A G E N D A

Architectural Review Board

December 20, 2017

PLANNING CONTROLS DIVISION

MADISON AVENUE

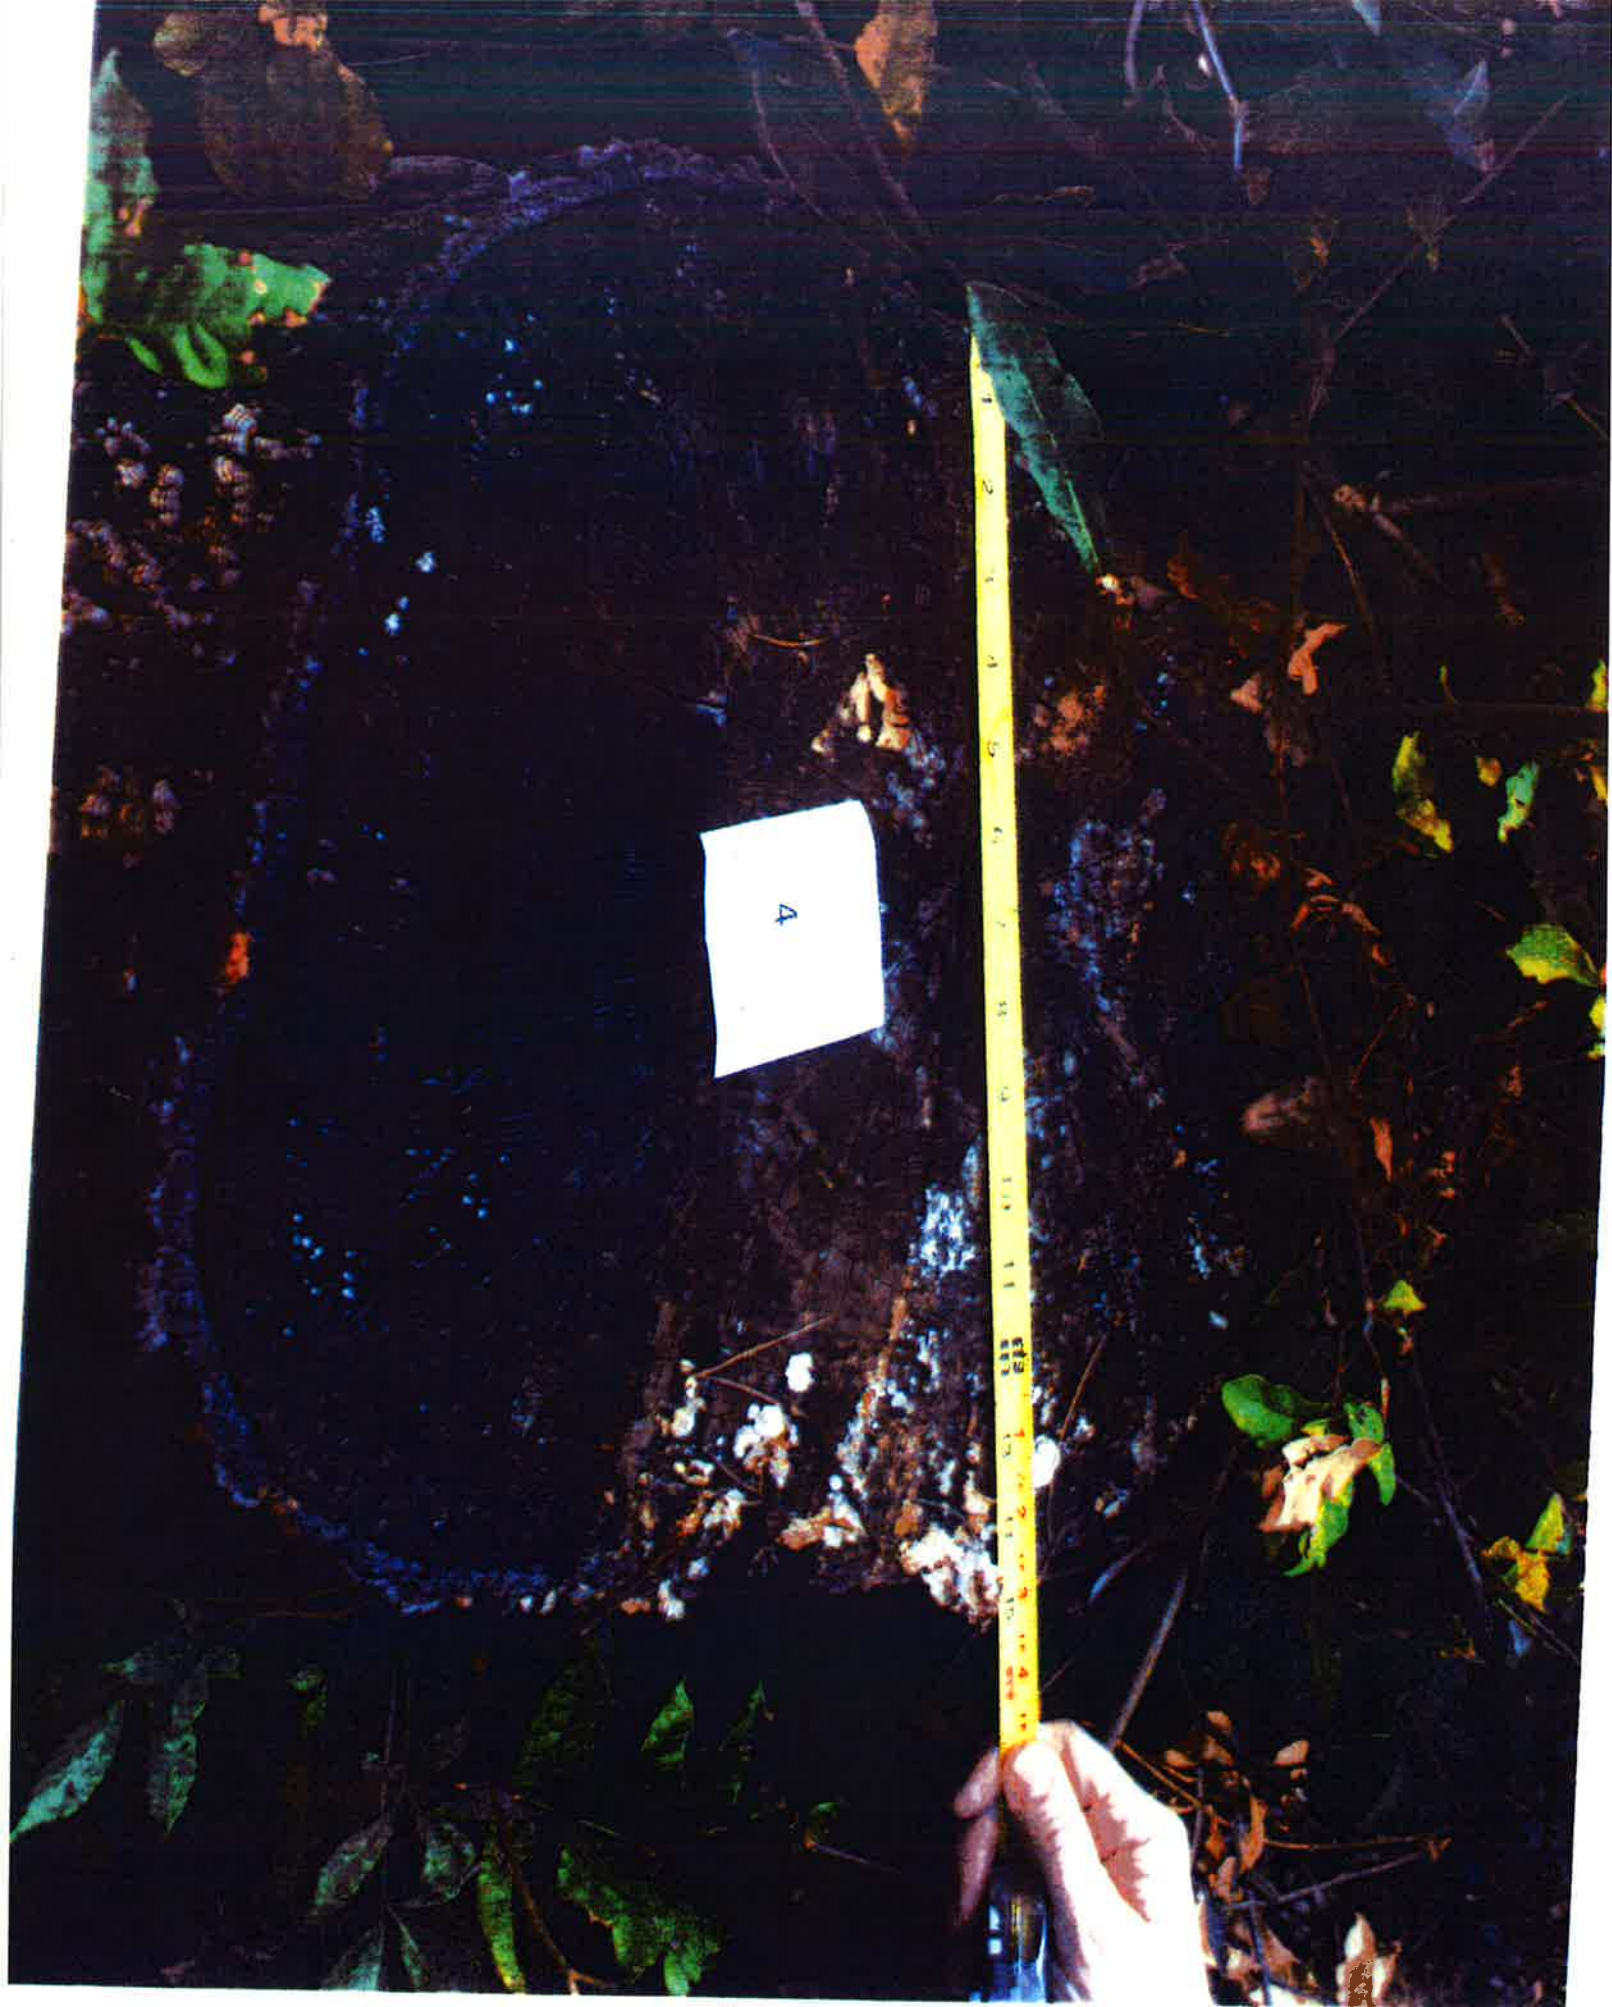
DEPARTMENT COMMENTS

- Replacements should meet size and quality standards from City Landscape Code (2.5" caliper).

SITE PLAN

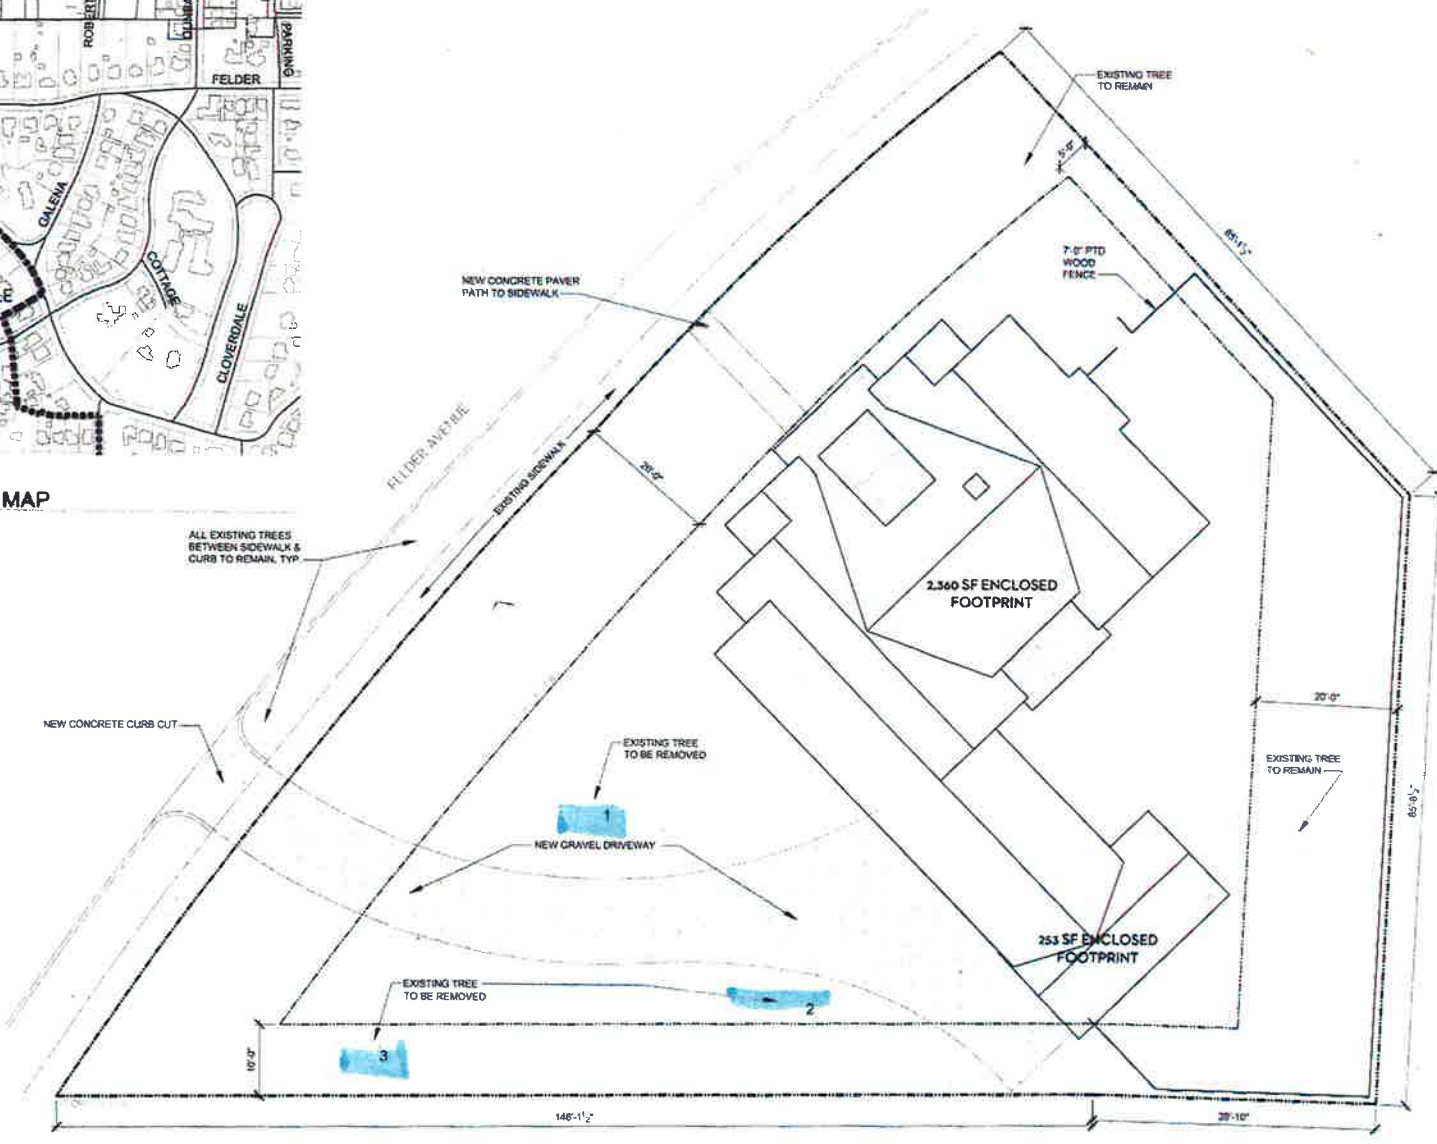
- At the time the agenda was prepared, the replacement plan had not been submitted.
